Downtown Code Design Review Committee

Meeting Minutes

June 4, 2020

1) Circle South

Figure 1: Korean Veterans Roundabout Elevation

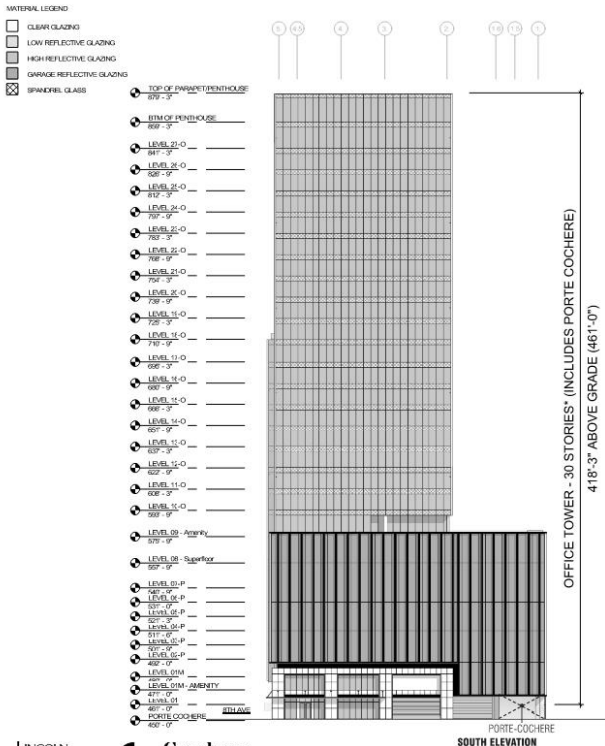
The DTC requires buildings greater than 7 stories to have a 15-foot step-back occur at some point between the 4th and 7th story. This project proposes a massing that leans away from the roundabout, but does not constitute a full-step-back as required. The intent of a step-back is to allow light and air to reach the street for the benefit of pedestrians and to avoid a canyon effect. Step-backs are most important for narrow streets, as increased proximity of buildings on the other side of the right-of-way has a greater potential to create a canyon effect.

However, diameter of both adjacent rights-of-way and the roundabout are very wide compared to most other streets within this subdistrict. In addition, the building is buffered from the right of way by pedestrian amenities and open space, allowing for more light and air to reach the street level.

Figure 1: East Elevation

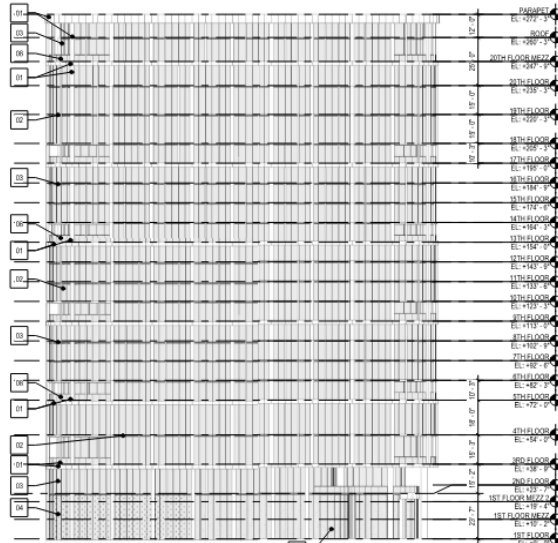
The DTC requires buildings greater than 8 stories to have a 15-foot step-back occur at some point between the 4th and 8th story. The intent of a step-back is to allow light and air to reach the street for the benefit of pedestrians and to avoid a canyon effect. Step-backs are most important for narrow streets, as increased proximity of buildings on the other side of the right-of-way has a greater potential to create a canyon effect.

The proposed building does not step-back at the eastern portion of the tower, but steps back well over 50 feet on the eastern portion of the tower. In addition, the building is set back by 26 feet from the back of the public sidewalk, with a robust outdoor seating area and landscaped plaza. The proposed massing will meet the intent of the step-back.
